## ASSESSMENT REPORT

### Block 11 - Central Park, Chippendale SSD 6376 MOD 2

This report is an assessment of an application seeking to modify the State significant development (SSD) consent (SSD 6376) for a mixed-use development known as Block 11 at Central Park, in the Sydney local government area.

**Figure 3:** Approved (top) and modified (bottom) Levels 7 and 8 layout including the creation of two, 1-bedroom apartments (Base source: Applicant's EIS)

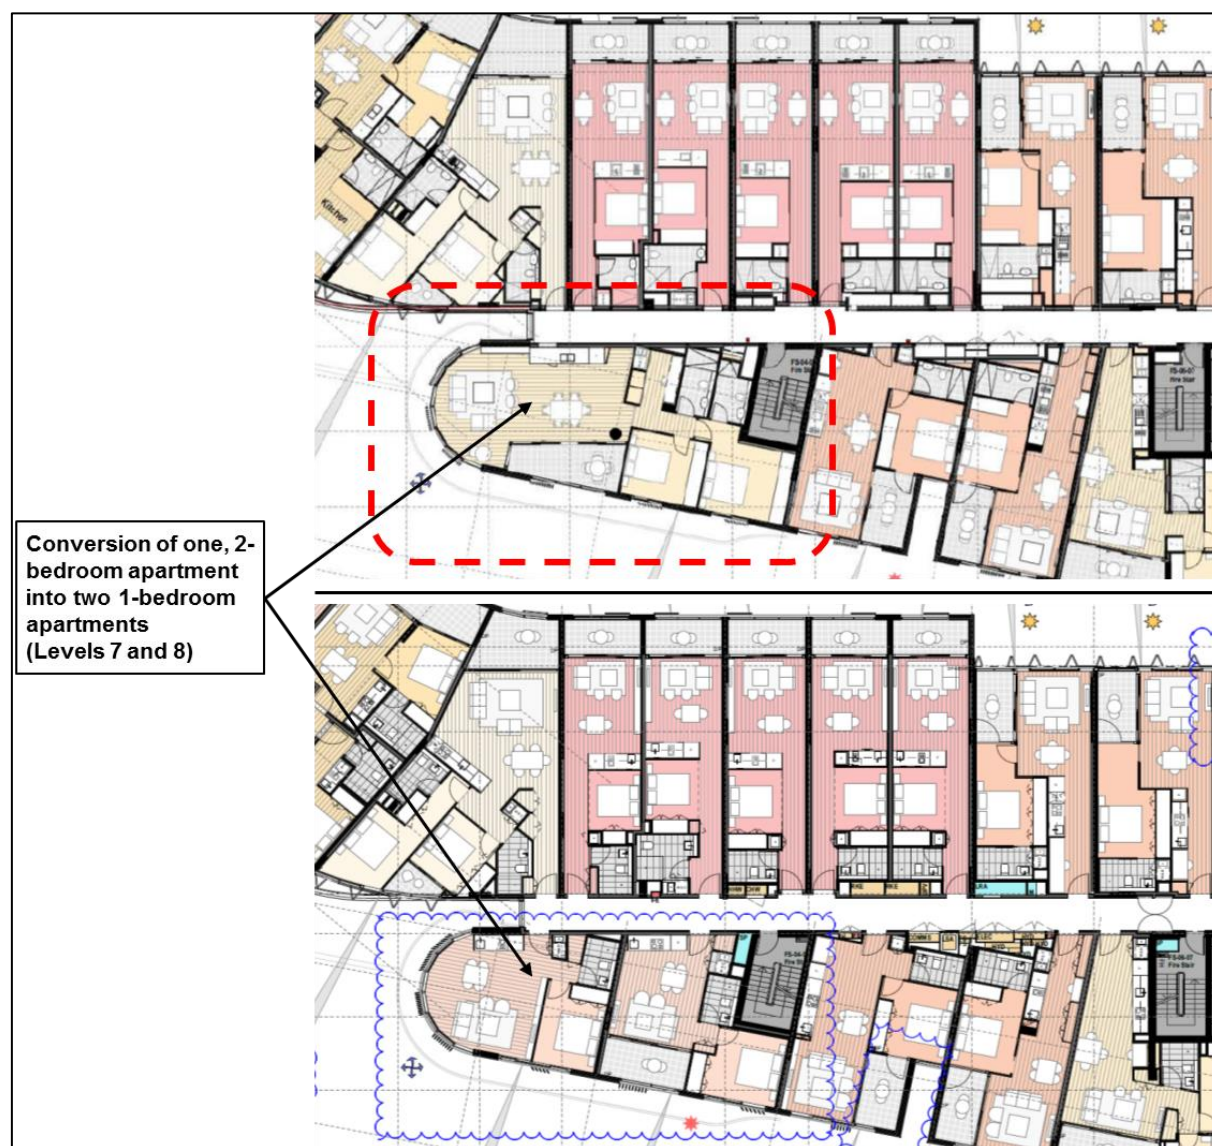
- conversion of two, 2-bedrom apartments (Levels 7 and 8) into four, 1-bedroom apartments (**Figure 3**)
- amalgamation of two, 2-bedroom apartments (Level 3) into one 4-bedroom apartment (**Figure 4**).

The Department notes two of the proposed 1-bedroom apartments are 6 m<sup>2</sup> below the ADG minimum size requirement. The Department raised concern about the amenity of these apartments and in response, the Applicant agreed to amend the apartments to address the shortfall. The Department recommends a new condition requiring the submission of amended plans to ensure these apartments comply with the ADG minimum size requirements.

Overall, subject to increasing the size of the two 1 bedroom apartment's the Department considers the modified apartments would still achieve an acceptable level of residential amenity.

**Figure 6:** Hydrant booster location (Base source: Applicant's EIS)

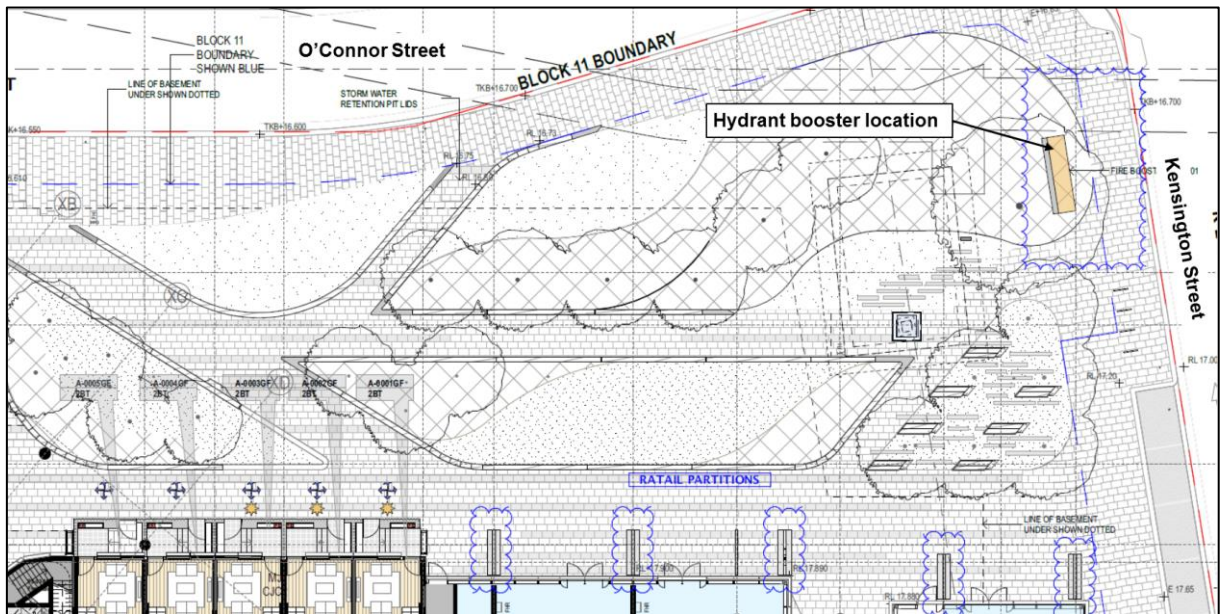
<i>Hydrant booster</i>	<ul style="list-style-type: none"> <li>The proposal includes the removal of the enclosure surrounding the approved hydrant booster, located within the O'Connor Street park (<b>Figure 6</b>).</li> <li>The Department notes the removal of the enclosure would reduce the visual prominence of the booster. In addition, the booster would be surrounded by landscaping comprising mounding and screen planting.</li> <li>The Department considers the removal of the booster</li> </ul>	No additional conditions or amendments necessary.

<i>Issue</i>	<i>Consideration</i>	<i>Recommendation</i>
	enclosure would not have an adverse visual impact on the O'Connor Street park and therefore considers it to be acceptable.	
<i>Materials</i>	<ul style="list-style-type: none"> <li>• Council initially raised concern about the proposed modification resulting in a reduction in the quality of the materials, more windows and deleted fins to balconies.</li> <li>• The Applicant has confirmed the majority of the materials remain unchanged and the type of brick to be used would be an earth/rust colour in accordance with the Concept Approval. In addition, the Applicant confirms the modification does not include an increase in windows or removal of fins.</li> <li>• The Department notes the only significant change to materials includes the replacement of timber with aluminium battens adjacent to the pedestrian through-link (<b>Figure 5</b>).</li> <li>• The Department is satisfied the proposed materials remain acceptable and the minor changes proposed would not reduce the overall quality, design or appearance of the building.</li> </ul>	No additional conditions or amendments necessary.

**Figure 8:** Deletion of the jacuzzi on Level 9 and reconfiguration of communal open space (Source: Applicant's EIS)

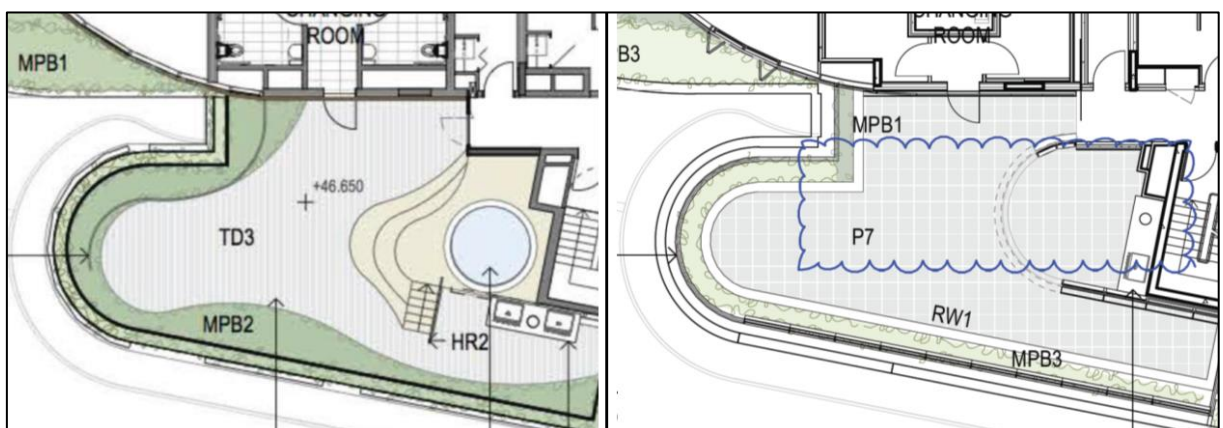
<i>Other minor internal and external alterations</i>	<ul style="list-style-type: none"> <li>• The proposal includes the following internal and external alterations to the building: <ul style="list-style-type: none"> <li>◦ minor amendments to the building façades (including windows, doors and balconies)</li> <li>◦ inclusion of CCTV</li> <li>◦ reconfiguration of basement layout, including car parking, residential storage and lift access</li> <li>◦ removal of the jacuzzi on Level 9 and reconfiguration of the communal open space at that level.</li> </ul> </li> <li>• The amendments to the building façades result in very minor alterations to windows, doors and balconies. The Department considers those changes would not be discernible from the SSD Consent and are therefore acceptable.</li> <li>• The proposed CCTV has been provided in accordance with the recommendations of the SSD Consent Crime Prevention Through Environmental Design report and are therefore considered appropriate.</li> <li>• The reconfiguration of the basement level results in a minor rearrangement of car parking spaces, residential storage areas and stair/lift cores. The modification does not propose to change the total number of car spaces, residential storage or access to the basement levels. The Department considers those changes are acceptable.</li> <li>• The Department considers the removal of the jacuzzi on Level 9 is acceptable, and notes this results in a corresponding increase in communal passive open space for recreation.</li> </ul>	No additional conditions or amendments necessary.
